2 Type of change

Packing improvement more stable box inlay.

New packing of FKH, FKI, FKHD, FKID, FKG					0118.2306	
creation date	created by	release date	released by	notification no.	revision	page
2015-09-10	buechlpj	2015-09-28	buechlpj	27949	-	1 of 2

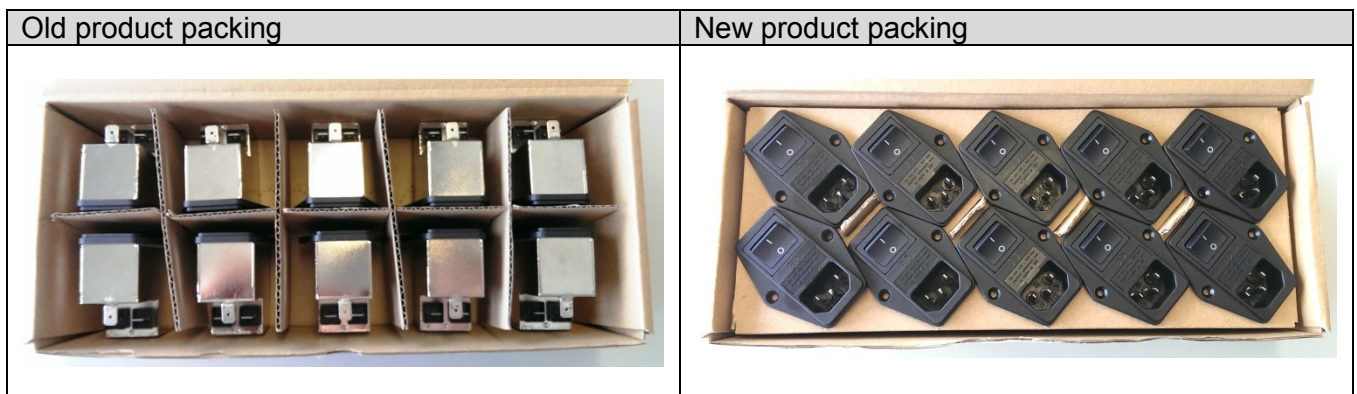
Type of packing inlay changed from separators to a tray.
No change of cardboard box or packing unit.
